RE: Project No. 10046, SCH No. 2004061029, “Castlerock” at East Elliot

California Chaparral Institute and Preserve Wild Santee respectfully submit the following comments.

Vernal Pool 28

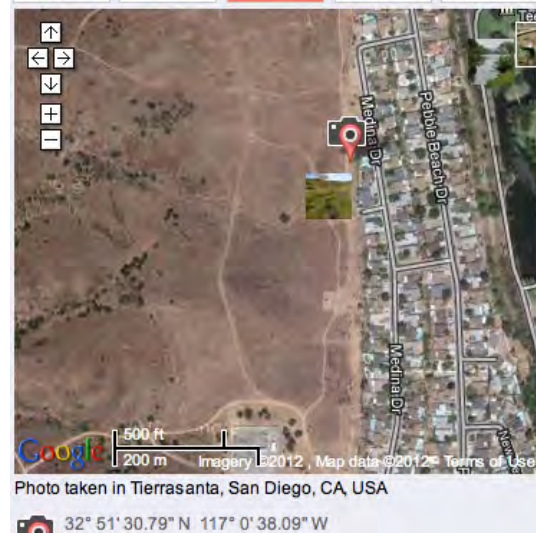
Our letter of March 27, 2011 requested avoidance of vernal pools and streams in the following locations. Which of these locations have been avoided and what is the size of the buffer for each avoided pool? The buffers appear to be inadequate leaving the pools vulnerable to significant adverse edge effects from new development. Which of the following pools contain the endangered San Diego Fairy Shrimp?

Latitude: 32° 51' 28.21" N
Longitude: 117° 0' 39.15" W
Creek 33

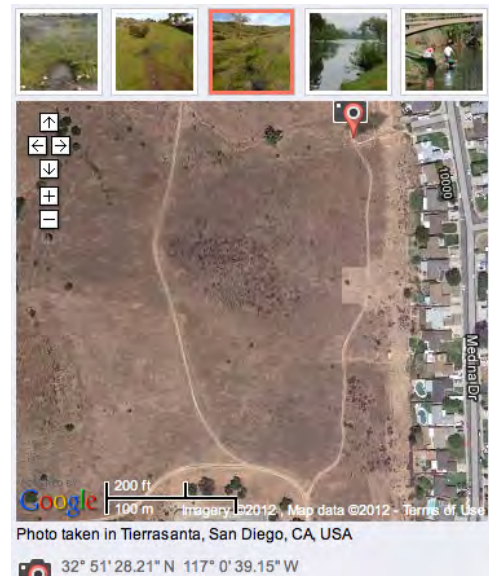
Creeks need to be avoided and 100 feet minimum buffers established. All development should be consolidated south of "Creek 33."
